PROPOSED TECHNICAL SPECIFICATIONS CHANGES

RE: License No. R-62, Docket No. 50-124

SUBJECT: Proposed Change to Technical Specifications

EXISTING PIPING DIAGRAM

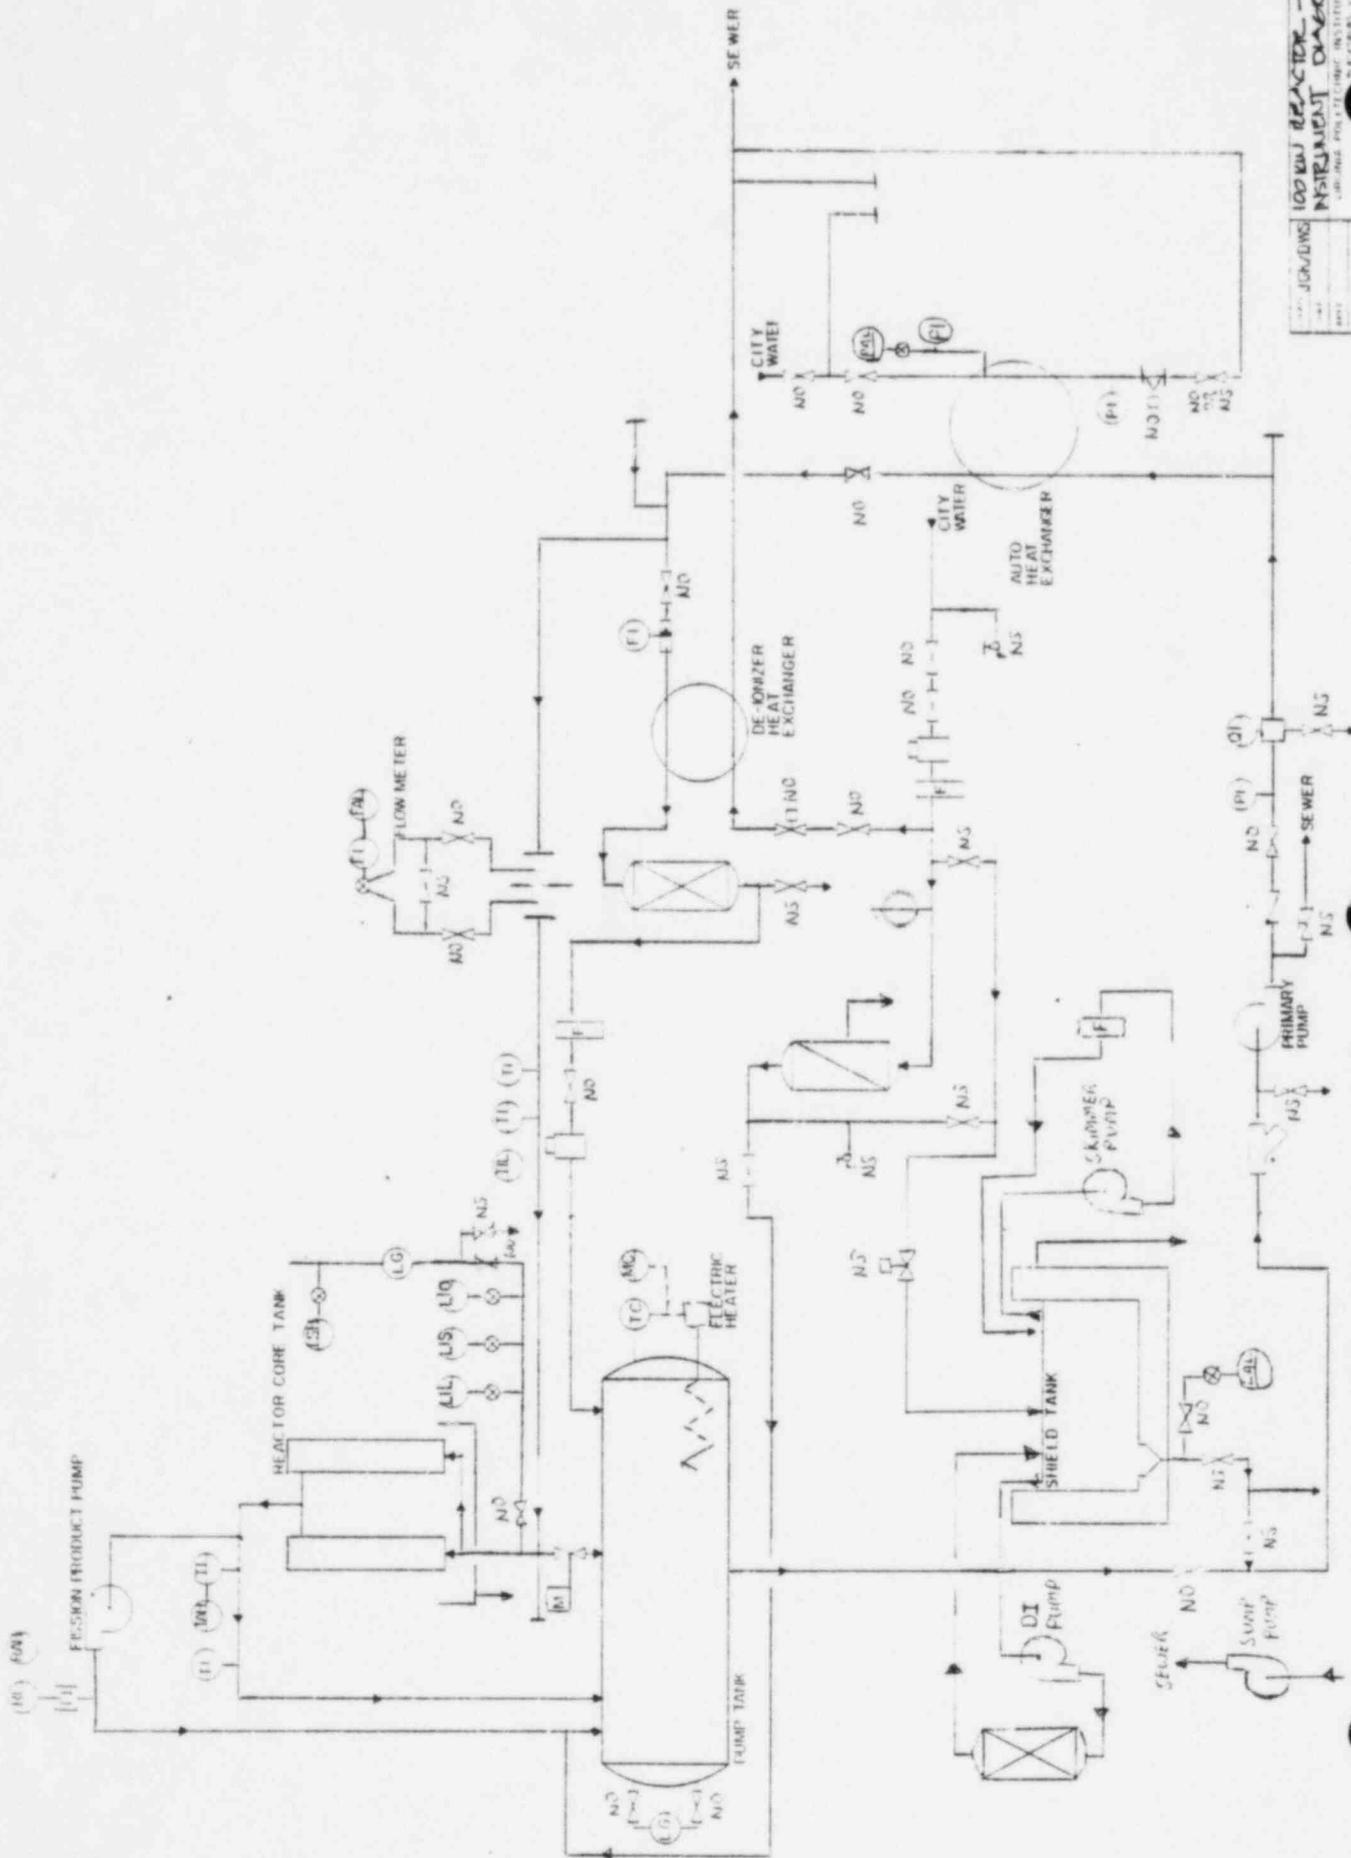
Page 3 Delete all of para. 5

5.0 Secondary Cooling System

- 5.1 The secondary coolant system shall consist of piping, a cooling tower, pump, cold side of heat exchanger and a flow throttle valve.
- 5.2 The secondary cooling system shall be maintained at a higher pressure than the primary coolant system during reactor operation.
- 5.3 Secondary coolant water shall utilize corrosion and organic growth inhibitors.

Page 2 para. 4

change 4.1 to read:

- 4.1 The primary coolant system shall consist of piping, a storage tank, pump, hot side of heat exchanger, 2 core tanks and a dump valve, demineralized water shall be used as the primary coolant.

PROPOSED NEW PIPING DIAGRAM

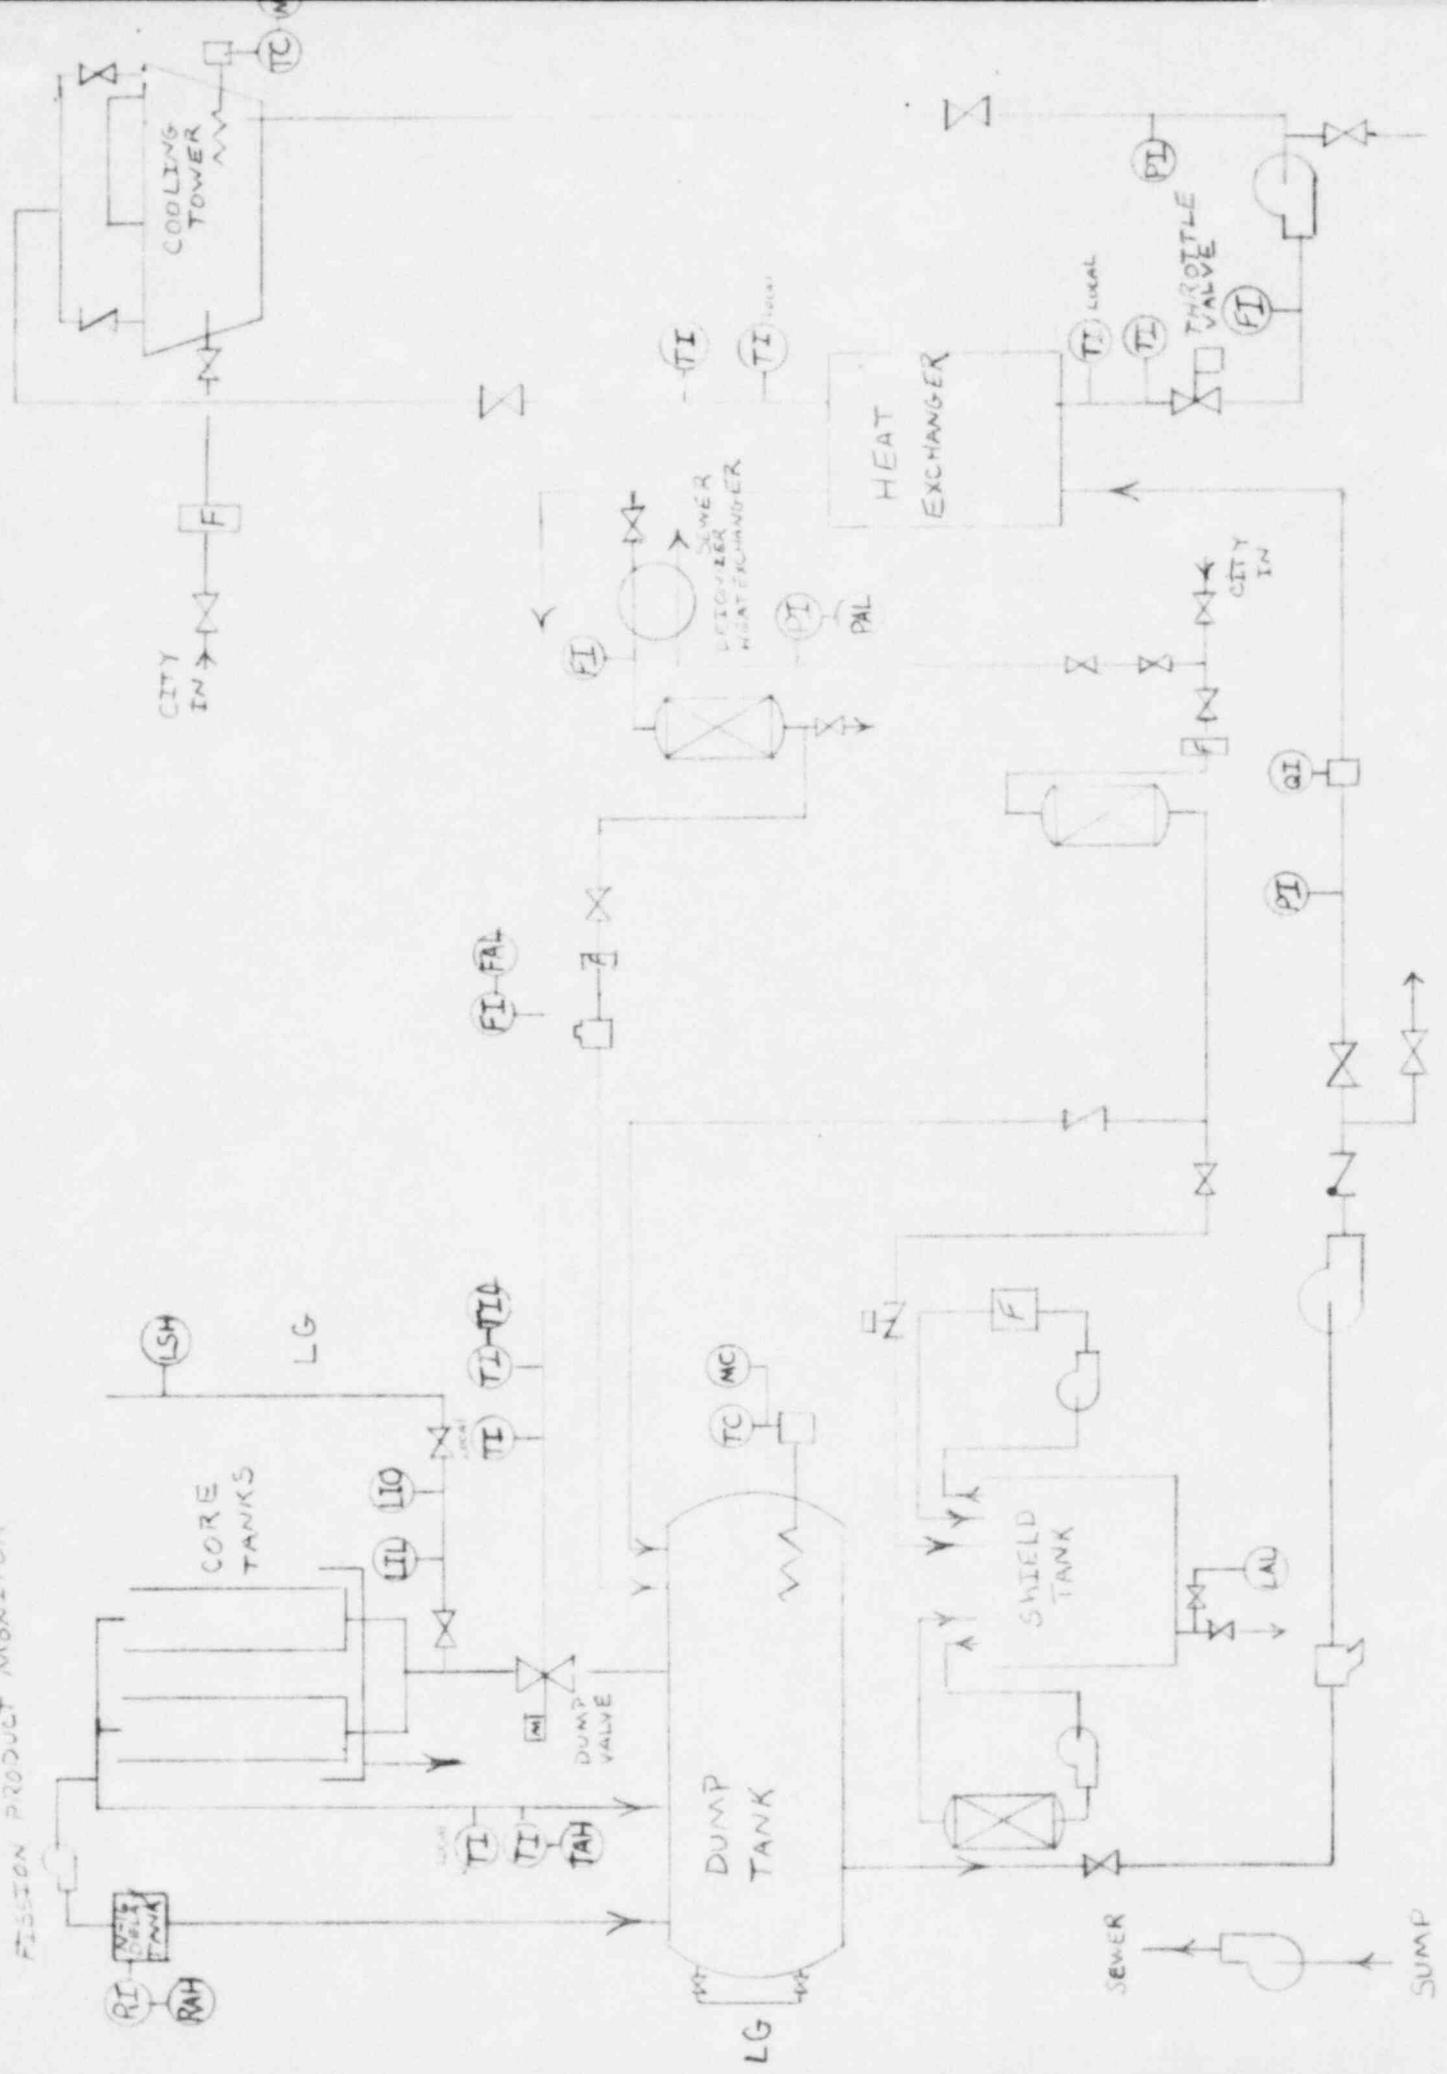
add one extra item #18

<u>Item</u>	<u>Sensor</u>	<u>Set Point</u>	<u>Action</u>	<u>Bypass Provision</u>
18. loss of secondary flow	Flow sensor, minimum of 1% accuracy, in secondary piping	Greater than 50 GPM	Annunciate	May be bypassed for operation under a power level less than 1 kW.
